City of St. Augustine

Historic Architectural Review Board

A G E N D A

Thursday, March 21, 2019 1:00 p.m. *Amended

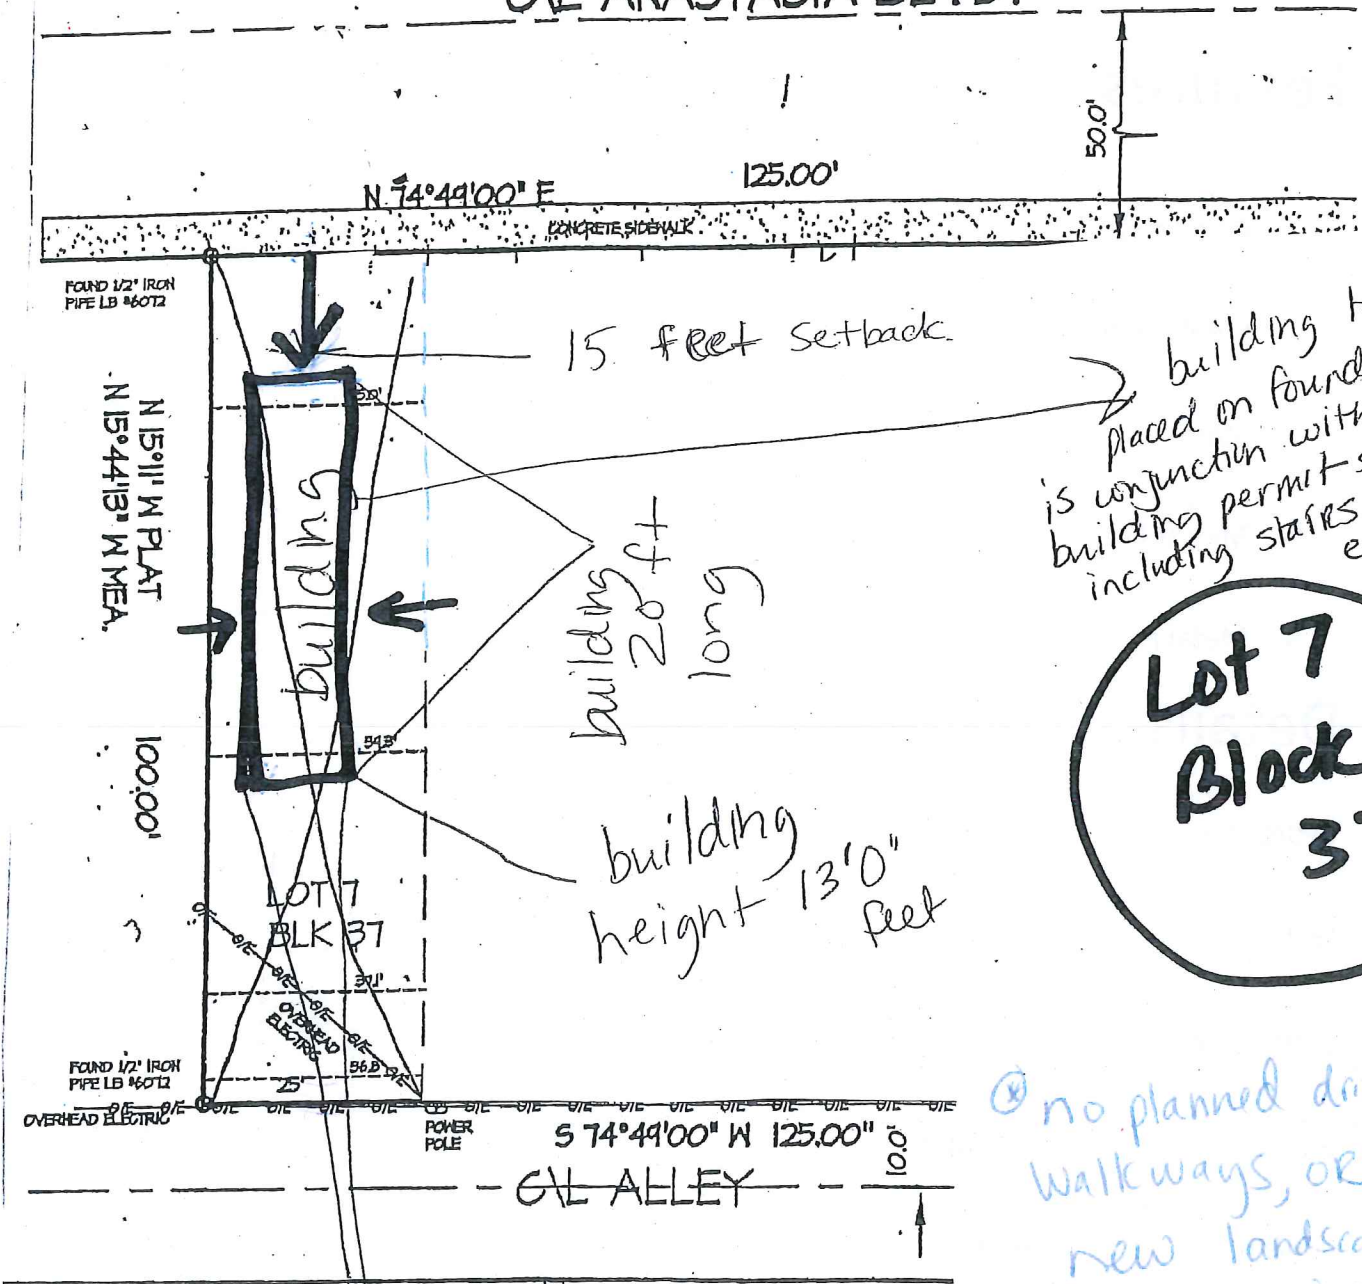
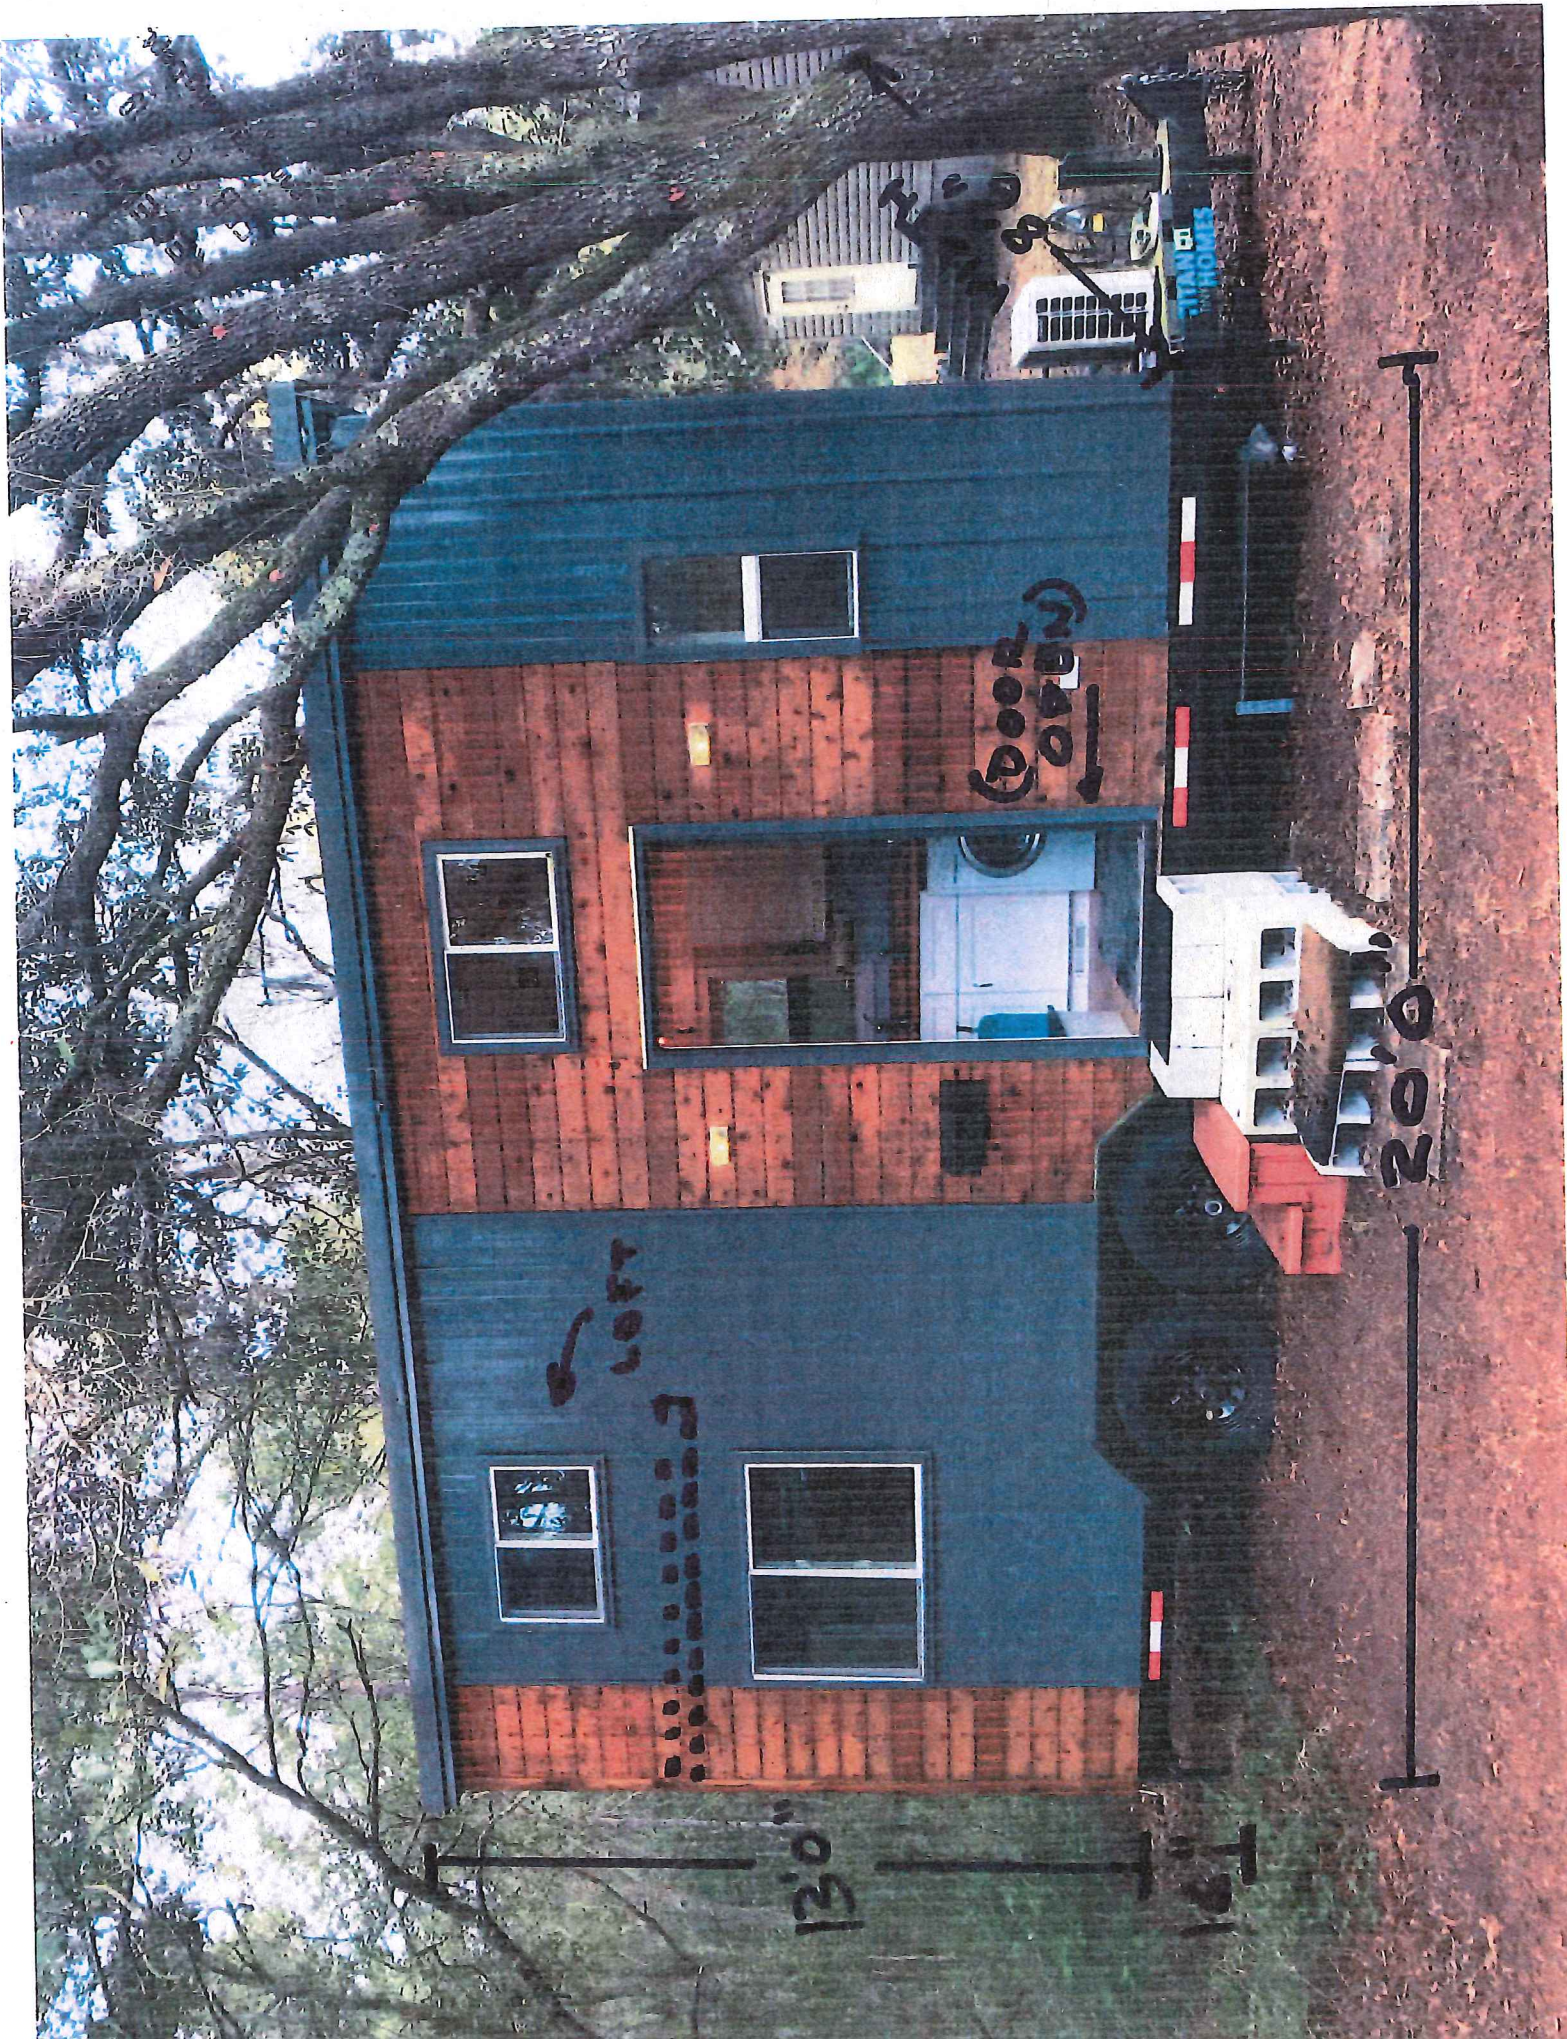
- place a pre-engineered building on the property consistent with the 'tiny-home' movement:
 - steel frame, 140 square feet, measuring 20 feet long, 8 feet wide, and 13 feet high
 - siding includes corrugated metal siding with ribs running in vertical orientation, 1x6 stained cedar siding, and various sizes of vinyl horizontal siding, tinted, windows, and a front residential door with two vertical panels and 6-lite transom
 - foundation and patio/stoop access information not provided at the time of application
